POLICY REPORT DEVELOPMENT AND BUILDING

SUBJECT: CD-1 Rezoning: 5355-5389 Cambie Street

5355-5389 Cambie Street DRAFT CD-1 BY-LAW PROVISIONS

5355-5389 Cambie Street DRAFT CONDITIONS OF APPROVAL

East Elevation (Cambie Street)

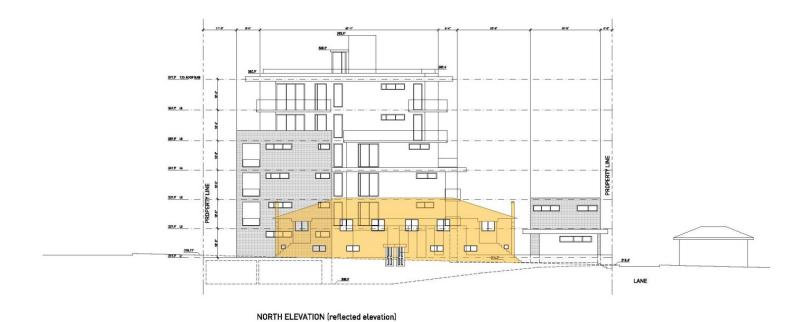
2. Design development to provide larger side yard setbacks, particularly at the north side.

3. Design development to reduce potential overlook impacts on the adjacent site to the north.

The Panel had some concerns regarding the child's play space as they thought it was not in the best place and too small. As well the Panel thought the roof was not developed enough and thought there should be an indoor amenity in the building as community space or room for strata meetings. It was suggested that an amenity room could be added to the roof area. One Panel member noted that the wall enclosing the parking ramp on the north side needed some design development to make it friendlier to the neighbours.

Note to Applicant: A minimum side yard setback of 12 feet should be provided at the north side to improve the transition to the existing and future development at the smaller site. The high solid wall at the north property line adjacent the parking drive aisle is not supported and should be deleted. Walls at the side property line may not exceed 6 feet fence height.

Note to Applicant: A reflected elevation should be provided showing the profile and window locations for the existing building on the adjacent site to the north. New windows should not directly overlap or provide undue overlook towards existing windows.
